Groundwater Application Review Summary Form

Application # G- 18637

To: Kristopher Byrd, Well Construction and Compliance Section Manager
From: Joel Jeffery, Well Construction Program Coordinator
Subject: Review of Water Right Application G-18637
Date: October 22, 2018

PUBLIC INTEREST REVIEW FOR GROUNDWATER APPLICATIONS

Well Location Map – showing where Willamette Silt has been removed

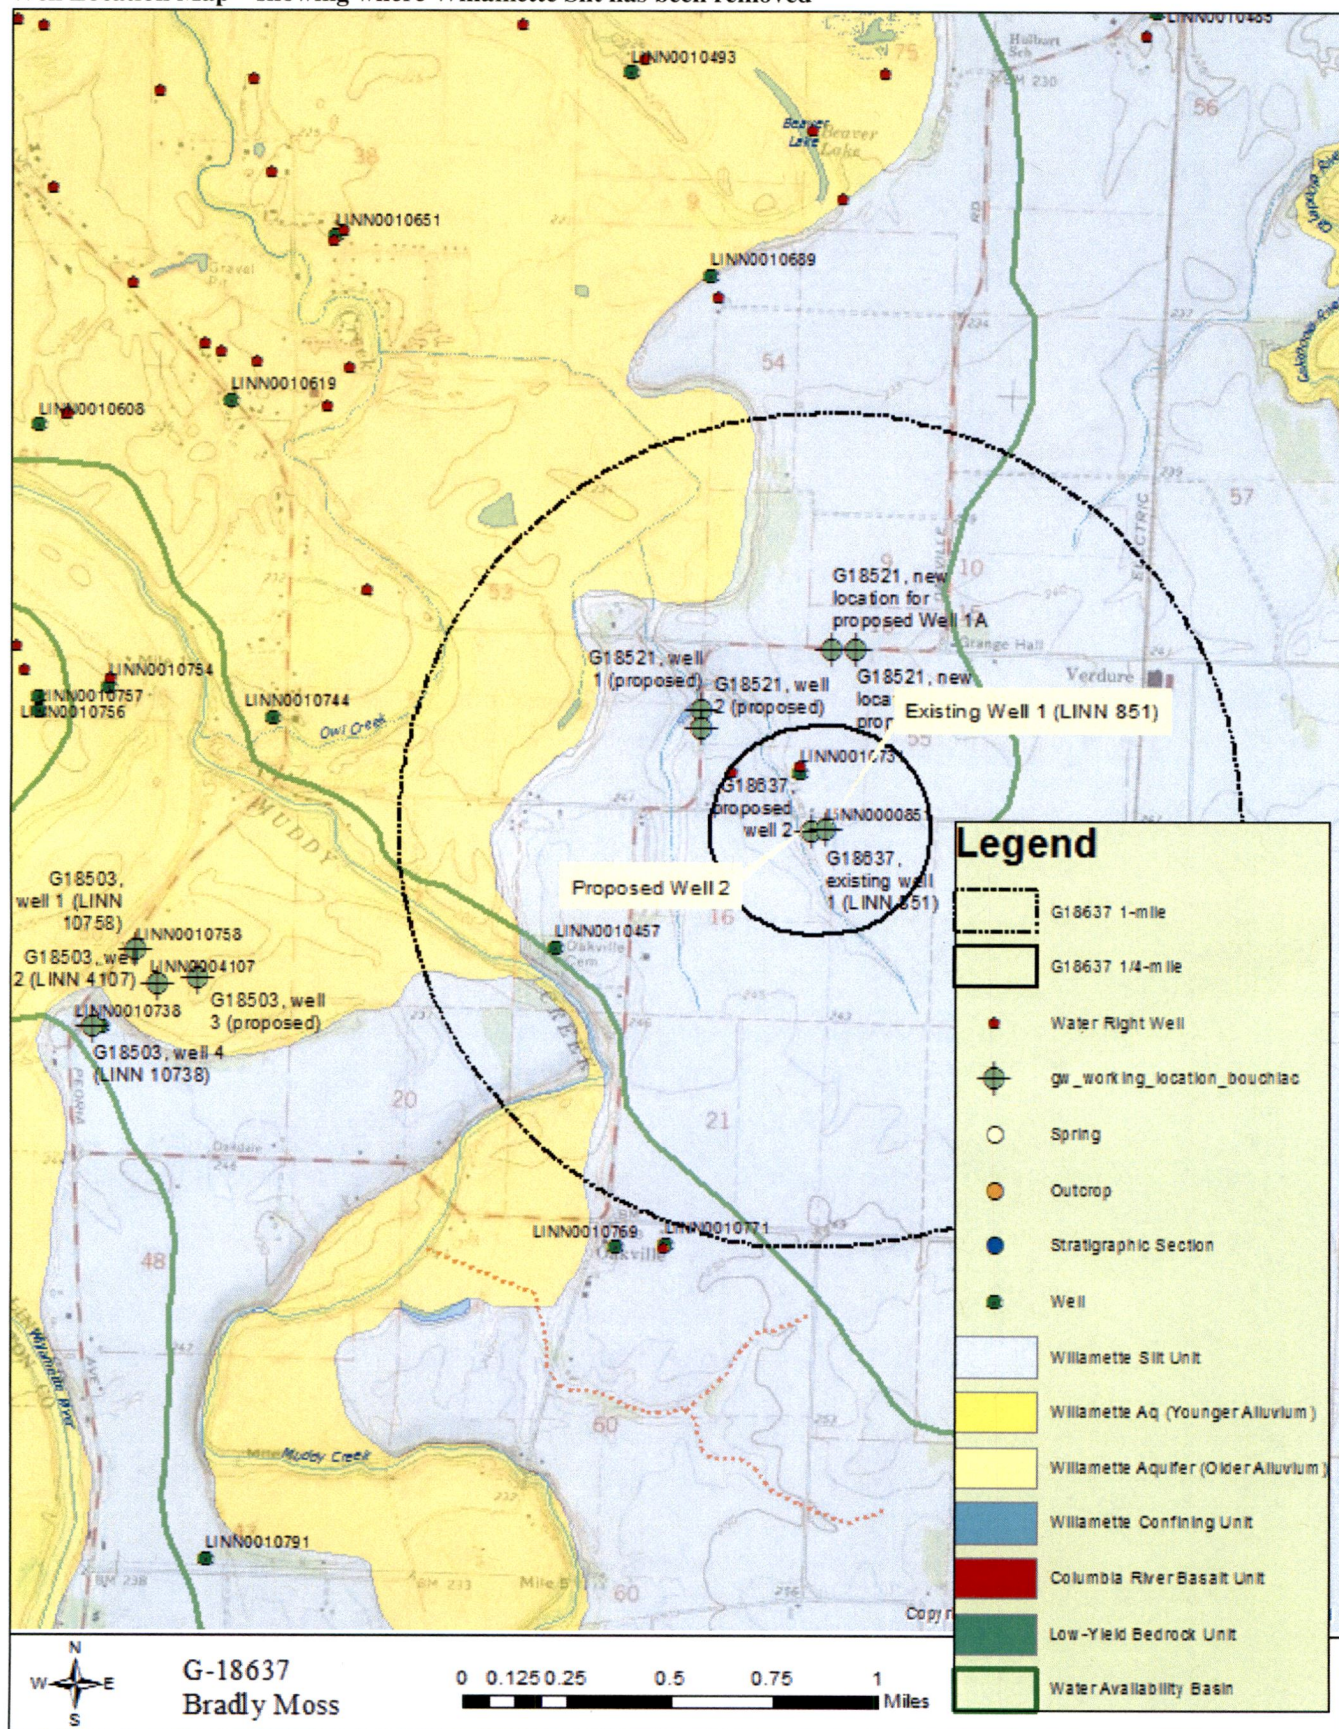
The area around the proposed wells is likely underlain by approximately 20 feet of Willamette Silt which is underlain by a series of sand and gravel beds interbedded with silts and clays (Gannett and Caldwell, 1998). The water table occurs near land surface in the Willamette Silt which acts as an extensive confining unit.

Water-Level Trends in Nearby Wells

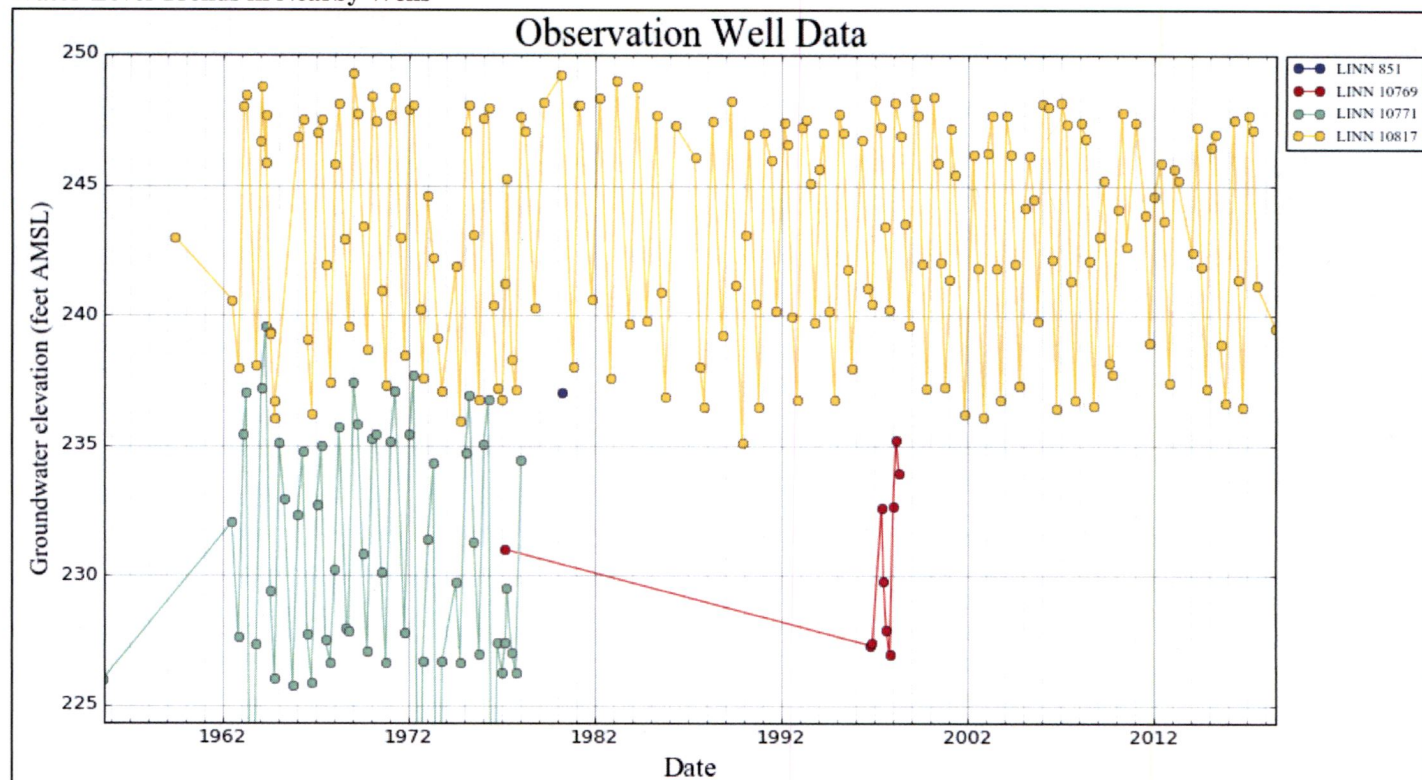
The nearest observation well (LINN 10817, located approximately 3.75 miles up-gradient to the southeast) has been monitored since the early 1960's. The hydrograph for LINN 10817 shows a seasonal fluctuation of approximately 10-15 feet and no apparent decline, suggesting the aquifer is stable at the current level of use. However, there has recently been a large amount of groundwater applied for in this area.

Stream Depletion Model Results

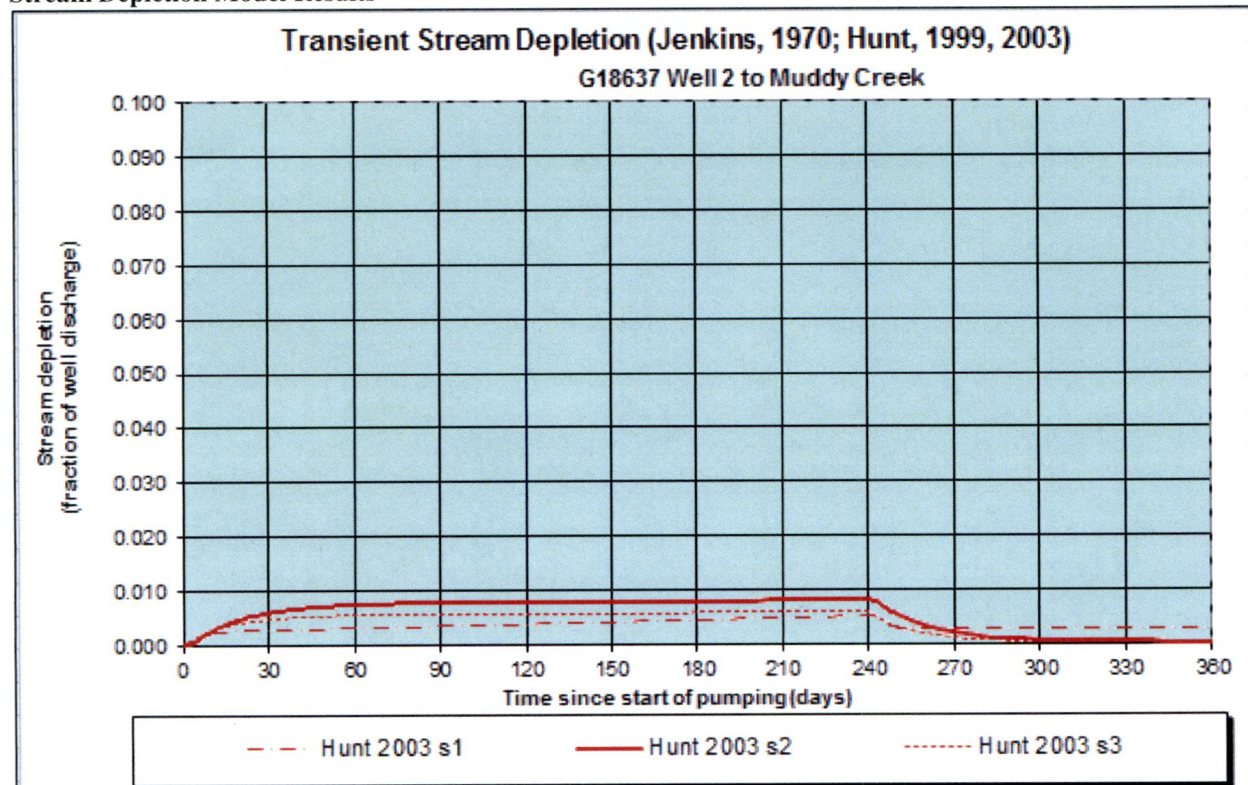
Comments: The stream depletion at 30 days was estimated using the Hunt 2003 model. Stream depletion was calculated using the ranges of S, Kv of the streambed, Kh of the Lower Sedimentary Unit as described in Conlon et al. (2005). Only the impact from pumping at the location of Well 2 on Muddy Creek (Watershed ID: 30200303) was modeled – however the full rate of 0.11 cfs (50 gpm) from this well was modeled as a worst case scenario.
